ALLEN ORGAN CO. INC.
MACUNGIE PENNA.

WIRING DIAGRAM-
AMPLIFIER - TYPE 90

DRAWN BY RA Bickel	SCALE	MATERIAL	
CHK'D	DATE 8-1-58	DRAWING NO. 081-0187	
TRACED	APP'D

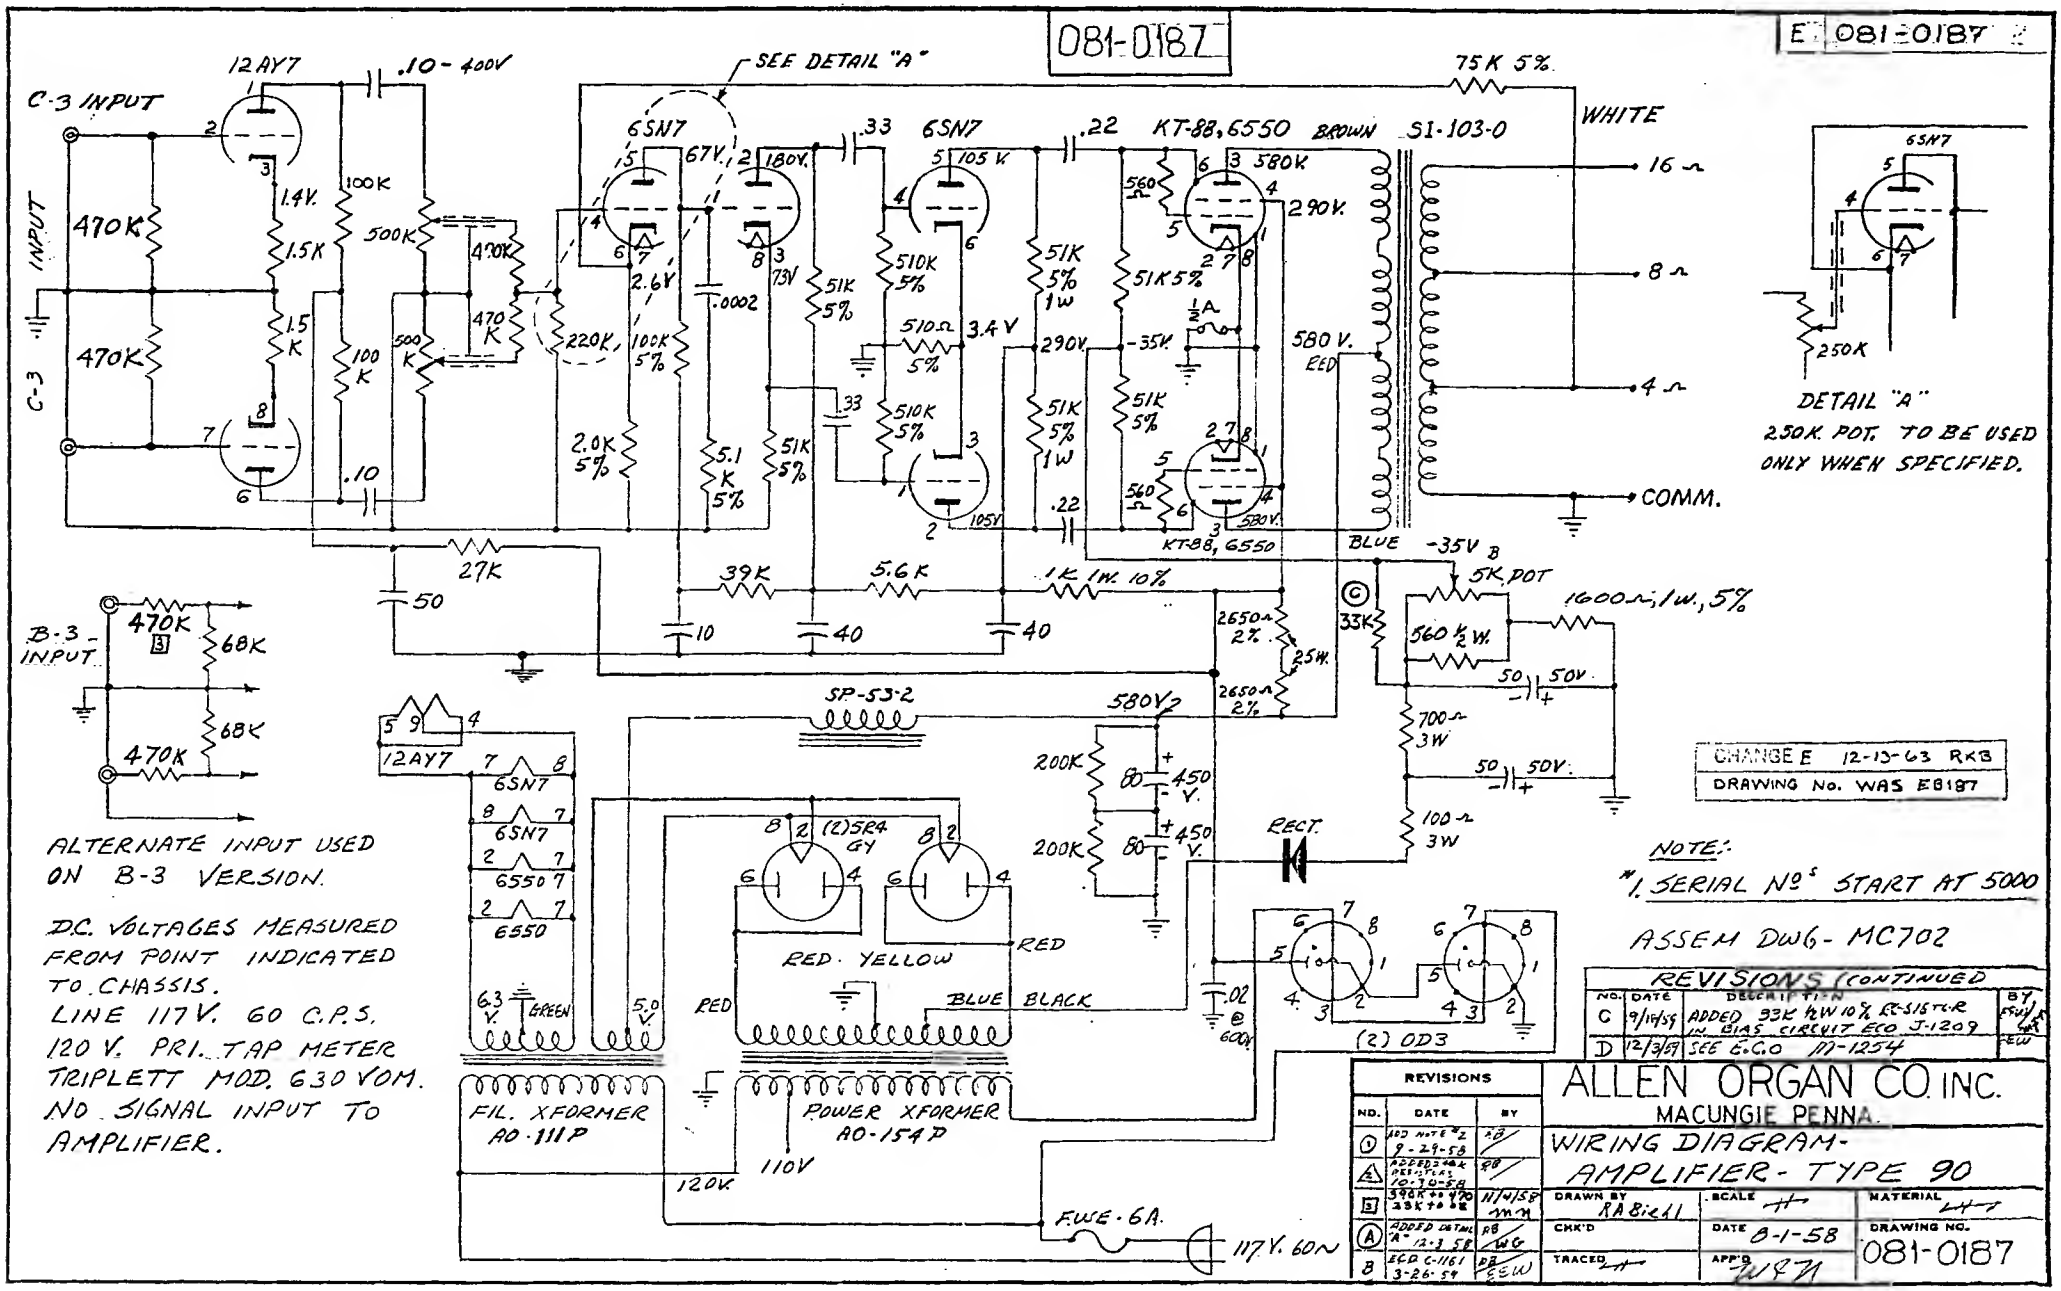
REVISIONS (CONTINUED)			
NO.	DATE	DESCRIPTION	BY
C	9/14/59	ADDED 33K ½W 10% RESISTOR IN BIAS CIRCUIT ECO J-1209	
D	12/3/59	SEE E.C.O 111-1254

REVISIONS		
NO.	DATE	BY
1	PER NOTE #2 1-29-58	RB
4	ADDED 3.3K RESISTOR 10-30-58	RB
5	390K to 470K 33K to 39K	11/4/58
A	ADDED DETAIL "A" 12-3-58	RB
B	ECO C-1161 3-26-59	RB
